# Access Compliance Report

### (Curb Ramps)

Intersection ID: N/A	Main Street: E_4TH_ST	Cross Street: N/A	Location: SW
ADA ID: F27524D8D14D	Ramp Type: Perp	Initial Pass/Fail: Fail	Overall Compliance: No
Severity Score: 12.5			
Codes/Mitigation Info/Possible Solution		Field Measurements/Component Compliance

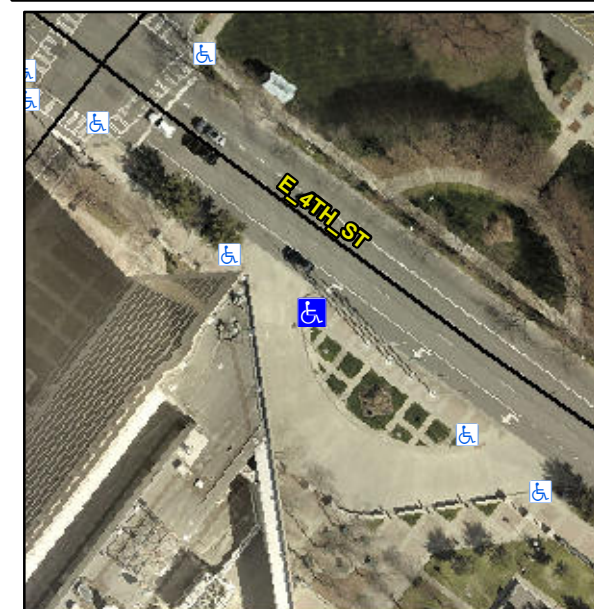
**R304.2.2**

Compliance	Description	Data	Compliance	Description	Data
N/A	Ramp Length (in)	81.0	No	Ramp Slope (%)	11.4
Yes	Ramp Width (in)	72.0	Yes	Ramp XSlope (%)	1.1
N/A	Flare Type LT	N/A	N/A	Flare Type RT	N/A
N/A	Flare Slope LT (%)	N/A	N/A	Flare Slope RT (%)	N/A
N/A	Flare Traversable LT?	No	N/A	Flare Traversable RT?	No
N/A	Landing Length (in)	N/A	N/A	DWS Provided?	N/A
N/A	Landing Width (in)	N/A	N/A	DWS Contrast?	N/A
N/A	Landing Slope (%)	N/A	N/A	DWS Length (in)	N/A
N/A	Landing X Slope (%)	N/A	N/A	DWS Full Width?	N/A
N/A	Landing Curb? (Y/N)	N/A	N/A	DWS Offset (in)	N/A
N/A	Shared Landing?	N/A			
N/A	Gutter Ponding?	N/A	N/A	Gutter Slope (%)	N/A
N/A	Gutter Lip Ht (in)	N/A	N/A	Gutter X Slope (%)	N/A
N/A	Painted X Walk1?	No	N/A	Painted X Walk2?	N/A
	X Walk 1 Direction	To NW		X Walk 2 Direction	N/A
N/A	X Walk 1 Width (in)	N/A	N/A	X Walk 2 Width (in)	N/A
	X Walk 1 Slope (%)	0.1		X Walk 2 Slope (%)	N/A
	X Walk 1 X Slope (%)	0.2		X Walk 2 X Slope (%)	N/A

**Remove & Replace Entire Ramp.**
